SERVICE INFORMATION NO. SI 42NG-086/2

Austro Engine Mandatory Service Bulletin No. MSB-E4-022 Rev. 3
ATA-Code: 71-00

No. MSB-E4-022/3
SUPERSEDES MSB-E4-022/2

Waste Gate Control Rod.

Figure 4: Waste Gate Circlip

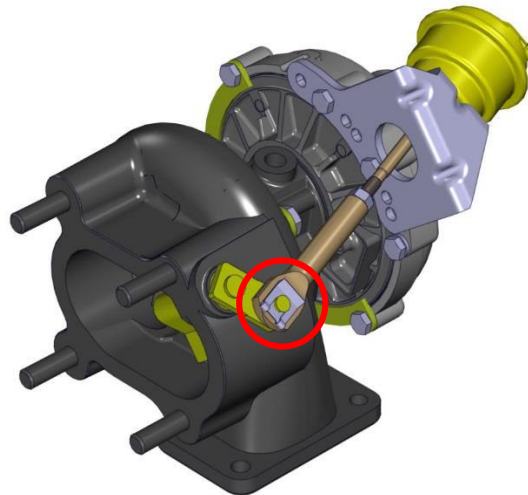
1. Make sure MM-TR-MDC-E4-386 and MM-TR-MDC-E4-399 are inserted into the Maintenance Manual or a revision of the Maintenance Manual with the Temporary Revisions incorporated is used.
2. Replace the waste gate controller according to Maintenance Manual section 81-00-33.
3. Install a new the spring loaded circlip E4A-41-100-801. Refer to figure 4

1. Replace the waste gate controller according to Maintenance Manual section 81-00-33.
2. Install a new the spring loaded circlip E4A-41-100-801. Refer to figure 4.

1. Make sure MM-TR-MDC-E4-422 is inserted into the Maintenance Manual or a revision of the Maintenance Manual with the Temporary Revisions incorporated is used.
2. If not yet installed, install a new spring loaded circlip E4A-41-100-801. Refer to figure 4.
3. Install the waste-gate con-rod fail-safe bridge according to Maintenance Manual section 81-00-36 or install a waste-gate controller with the fail-safe con-rod bridge already installed. Make sure there is sufficient clearance to adjacent parts.
